FINAL ENVIRONMENTAL IMPACT STATEMENT

By the New York State Department of Environmental Conservation

It's Greener Now, Inc. – Padua Gravel Pit

Article 23, Mined Land Reclamation, DEC #8-4424-00006/00001 (MLR#80244)

DATE: 9/04/2024 | SCALE: 1"=125' | DWG. NO. 16157002H | FIGURE 5

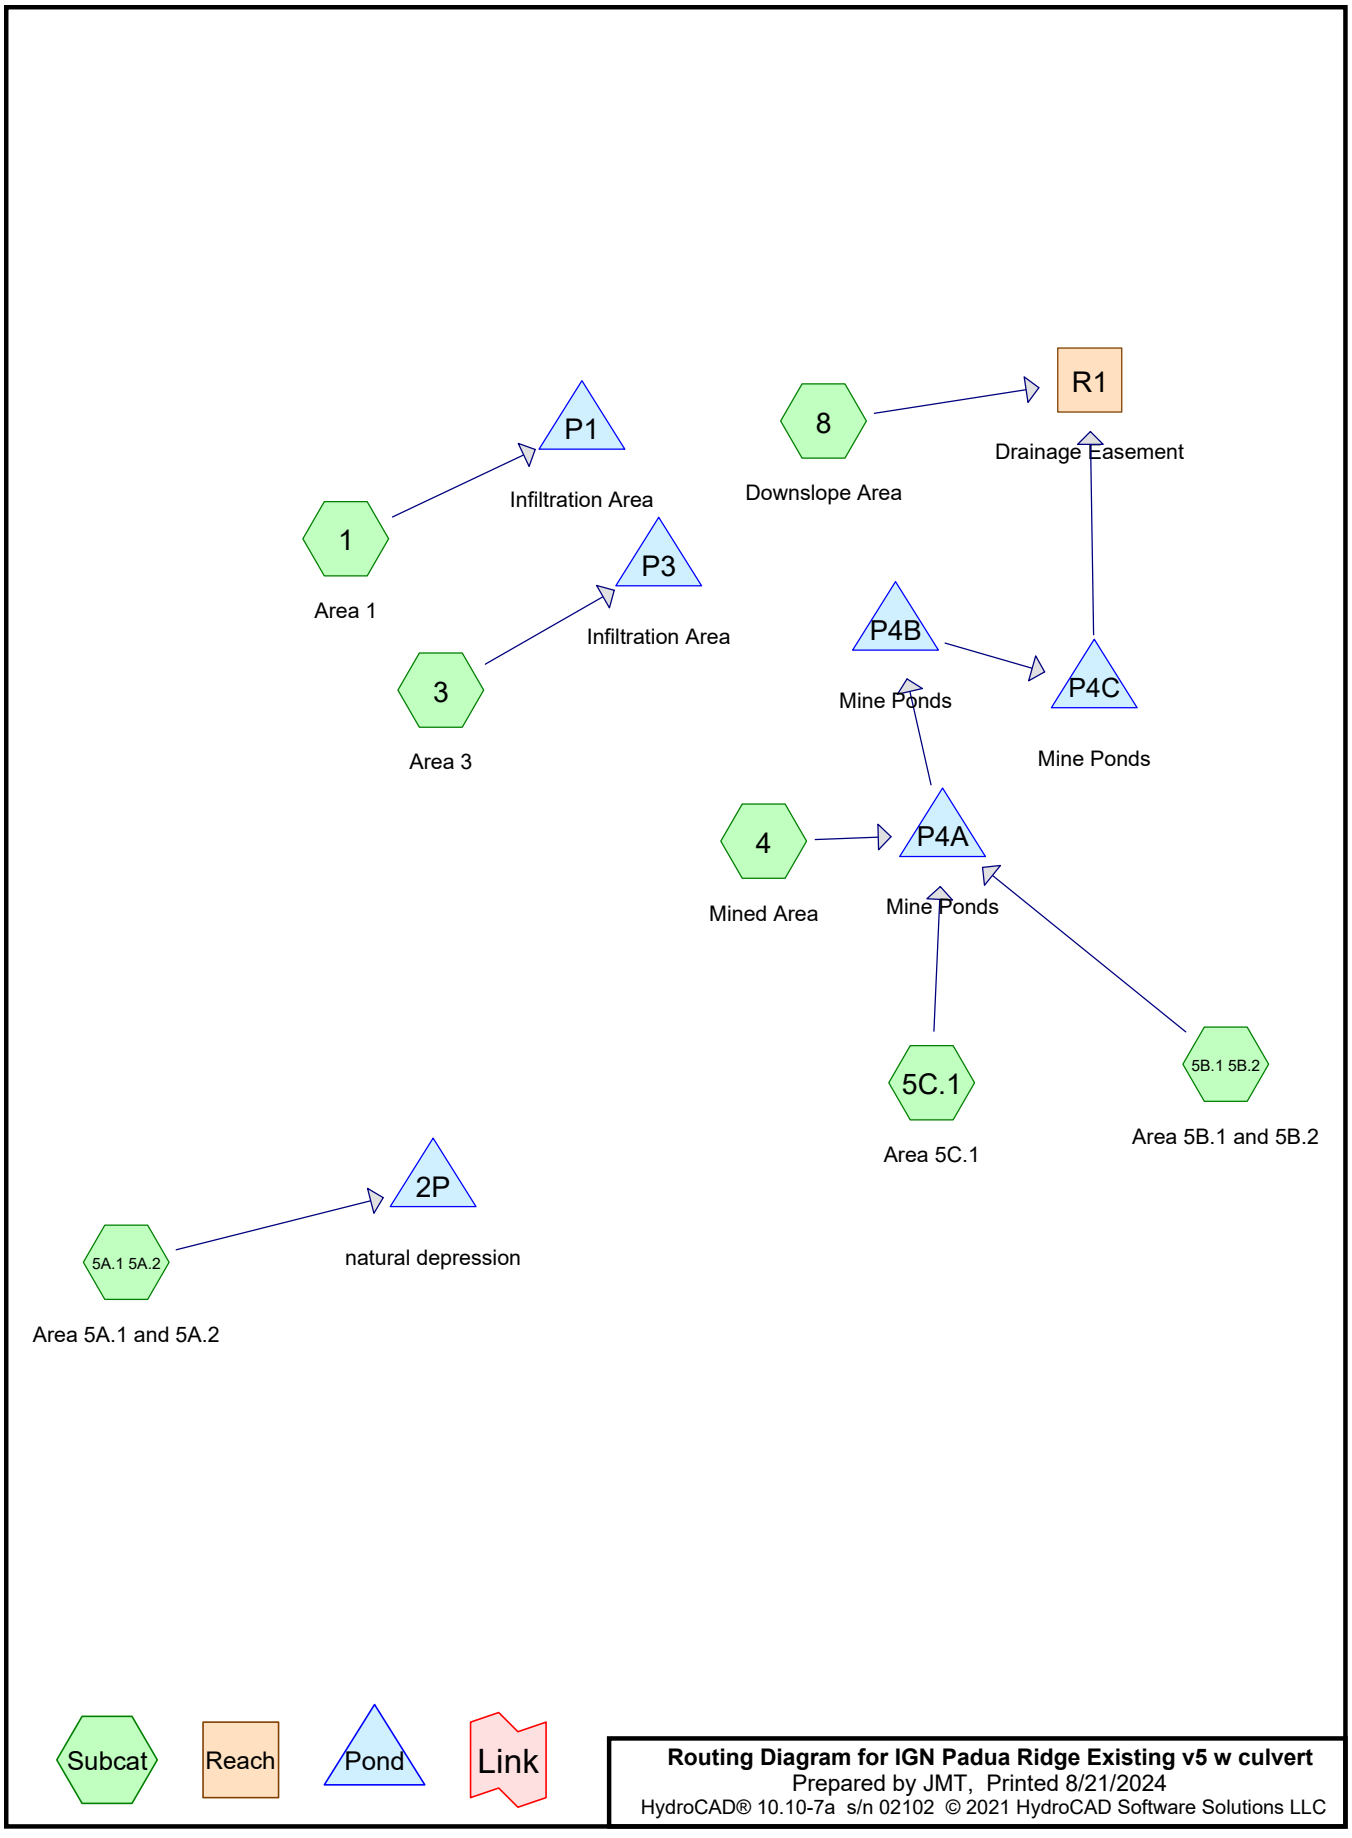
Response: For ease of review, a new drawing titled, *Stormwater Pond Configuration* has been created to show the groundwater elevations and pond dimensions. Please refer to the attached drawing, which will be included as Figure 5 in the Drainage Report for additional detail.
